September 8, 2011

Chief Clerk, MC-105
Texas Commission on Environmental Quality
P.O. Box 13087
Austin, Texas 78711-3087

Re: Public Comments Regarding Luminant Generation Company LLC Draft Renewal of Title V Permit No. O64, RN102285921

Figure 2. Area with 4th Highest 5-yr Averaged SO₂ Concentrations Exceeding the 1-Hour NAAQS of 196 ug/m³ by Plant Emissions Alone

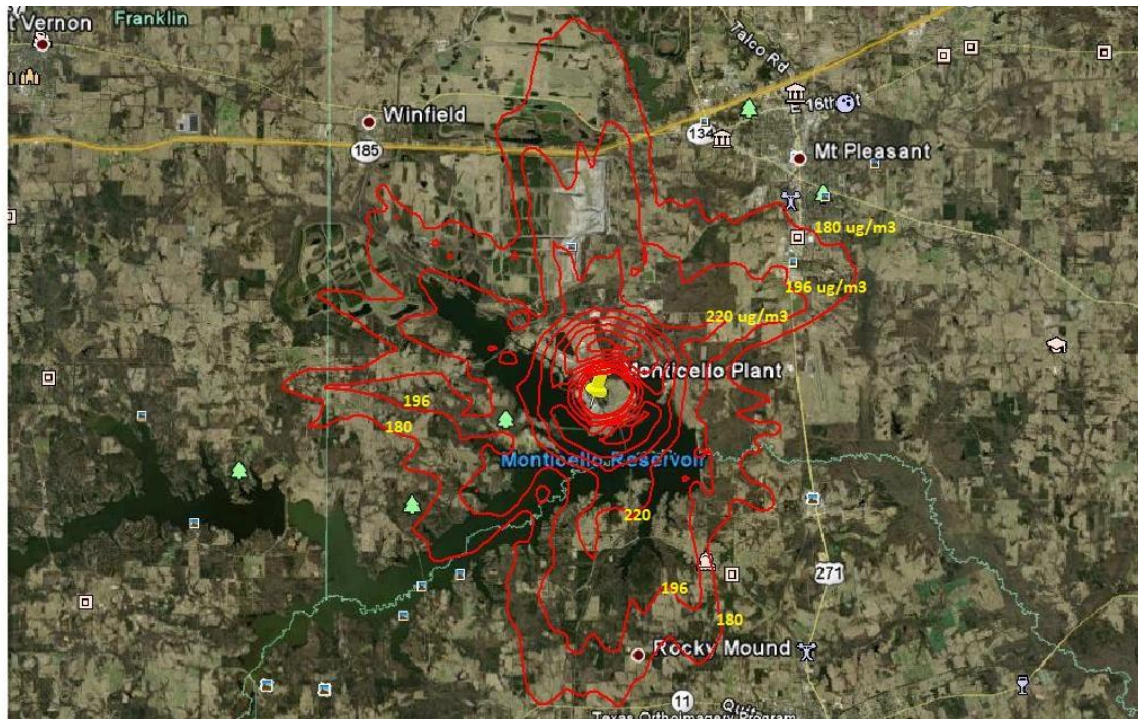
Modeling based on the Monticello Plant's actual emissions shows that emissions from the plant cause ambient air pollution to greatly exceed the one-hour SO₂ NAAQS. AERMOD Modeling of SO₂ Impacts of the Luminant Monticello Coal Plant, Khanh T. Tran (June 2011) (Exhibit B). Specifically, using 2003 actual emissions, five years of meteorological data and the latest EPA modeling guidance, the AERMOD model demonstrated that emissions from the Monticello Plant cause large exceedances of the one-hour SO₂ NAAQS. Excluding other sources and background concentrations, emissions from the Monticello Plant cause exceedances of the NAAQS in an area around the plant with a radius of approximately 6 miles. The town of Rocky Mound, located nearly 5 miles south of the plant, lies within the impact area.

Before the TCEQ may renew Luminant's permit, it must develop a compliance plan to reduce SO₂ emissions at the Monticello Plant, such that SO₂ emissions do not injure or adversely affect human health or welfare in the area surrounding the plant (i.e., such that they do not cause violations of the NAAQS). *See* 40 C.F.R. § 70.5(c)(8)(iii)(C). TCEQ may also not issue a Title V permit for the Monticello Plant without a compliance plan, because the Texas SIP requires that “the National Primary . . . Ambient Air Quality Standards . . . will be enforced throughout all parts of Texas.” 30 TEX. ADMIN. CODE § 101.21; 42 Fed. Reg. 27,894 (June 1, 1977). If TCEQ allows the Monticello Plant to continue operating as-is, the TCEQ is failing to enforce the one-hour SO₂ NAAQS. Furthermore, TCEQ should consider imposing more stringent SO₂ emission limitations on Monticello Units 1, 2, and 3. The Monticello Plant's pervasive and ongoing violations of the one-hour SO₂ NAAQS indicate that the plant's current SO₂ emission standards
